Project	IEEE 802.16 Broadband Wireless Access Working Group <http://ieee802.org/16>
Title	Corrections to OFDMA ranging definitions
Date Submitted	2004-06-26
Source(s)	<p>Intel :</p> <p>Yuval Lomnitz, yuvall@envara.com</p> <p>Dov Andelman, dov.andelman@intel.com</p> <p>Itzik Shahar, itziks@envara.com</p> <p>Noam Kogan, noamk@envara.com</p> <p>Yigal Eliaspur, yigal.eliaspur@intel.com</p> <p>Voice: +972-547-884877</p>

Re:	IEEE P802.16e/D3-2004
Abstract	The document proposes changes to correct two errors in the ranging definition.
Purpose	Correct erratas in 802.16REVd_D5 ranging definitions, concerning time domain description of ranging code, and ranging/BW request opportunity slot size.
Notice	This document has been prepared to assist IEEE 802.16. It is offered as a basis for discussion and is not binding on the contributing individual(s) or organization(s). The material in this document is subject to change in form and content after further study. The contributor(s) reserve(s) the right to add, amend or withdraw material contained herein.
Release	The contributor grants a free, irrevocable license to the IEEE to incorporate material contained in this contribution, and any modificatio

The time structure of initial ranging transmission appears in Fig.239:

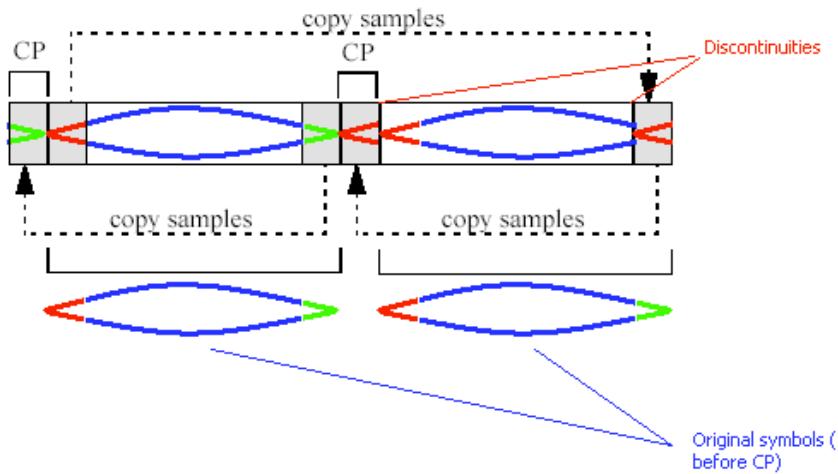
This diagram contradicts the text in 8.4.7.1, which requires phase continuity between the two symbols. The following diagram shows why:

The correct structure would be that the second symbol starts immediately at the end of the first symbol, and the remaining guard interval at the end of the second symbol is a cyclic extension.

8.4.7.1 Initial-ranging transmissions [Replace figure 239 with the following figure]

The transmitted signal is according to 8.4.2.5, equation (96), except that $0 \leq t \leq 2T_s$.

Figure 243a : Ranging/BW request opportunities

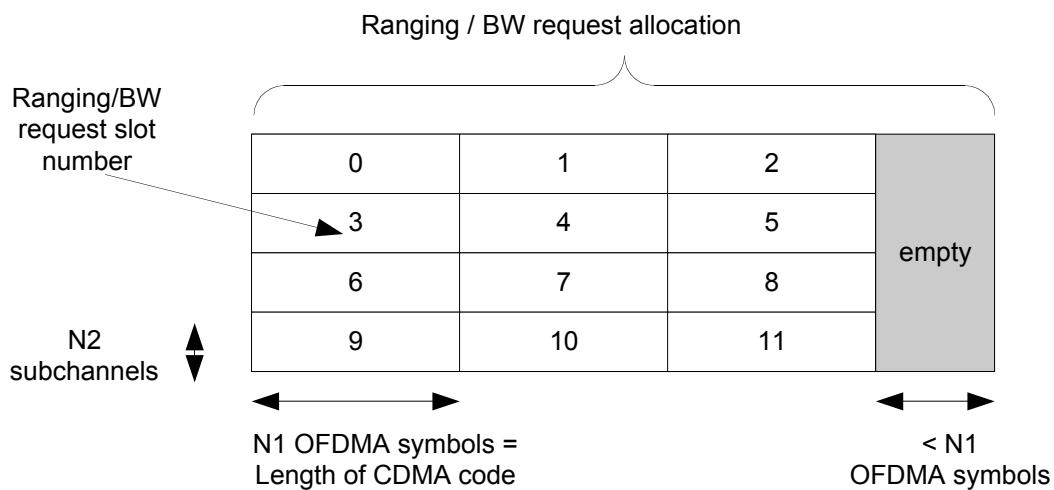
We propose to define the opportunity size in OFDMA as the length of the CDMA code.

For CDMA ranging and BW request, the ranging opportunity size is the number of symbols required to transmit the appropriate ranging/BW request code (1,2,3 or 4 symbols), and is denoted N1. N2 denotes the number of subchannels required to transmit a ranging code (6 or 8, see 8.4.7.3). In each ranging / BW request allocation, the opportunity size (N1) is fixed and conveyed by the corresponding UL_MAP_IE that defines the allocation.

The ranging allocation is subdivided into slots of N1 OFDMA symbols by N2 subchannels, in a time-first order, i.e. the first opportunity begins on the first symbol of the first subchannel of the ranging allocation, the next opportunities appear in ascending order in the same subchannel, until the end of the ranging/BW request allocation (or until there are less than N1 slots in the current subchannel), and then the number of subchannel is incremented by N2. The ranging allocation is not required to be a whole multiple of N1 symbols, so a gap may be formed (that can be used to mitigate interference between ranging and data transmissions). Each CMDA code will be transmitted at the beginning of the corresponding slot. See Figure 243a
